# City of Poulsbo

Subject: Johnson Ridge PRD & Preliminary Plat; P-08-02-19-01

# MEMO

**To:** Matt Hough, CPH Consultants  
**From:** Nikole Coleman, Associate Planner  
**Subject:** Johnson Ridge PRD and Preliminary Plat | P-08-02-19-01  
**Date:** December 31, 2019

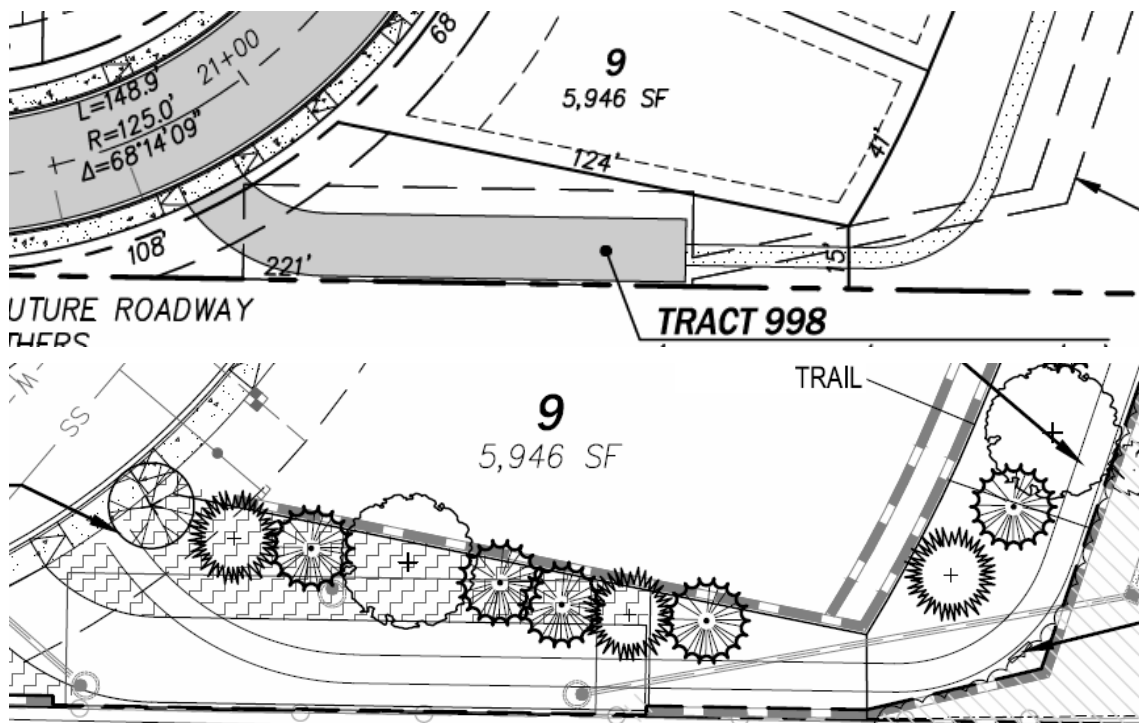
- a. Home sites 1-9 are proposed with a 110' lot depth. However, the PRD allows for a 70' depth. The topography behind lots 1-9 appears to allow for a lot depth less than 110' and moving the proposed path further west. This would decrease the impact proposed to the stream buffer and shall be addressed in your revised design. Keep in mind that staff does not support locating the 25' building setback within proposed lots as an easement.

- b. Also, the minimum lot width and lot depth allowed for a PRD has not been utilized throughout the plat, which would allow for less encroachment into the required stream buffer. Please address in your redesign. Note, proposed home designs shall also be revised with consideration for a reduced lot width and lot depth.
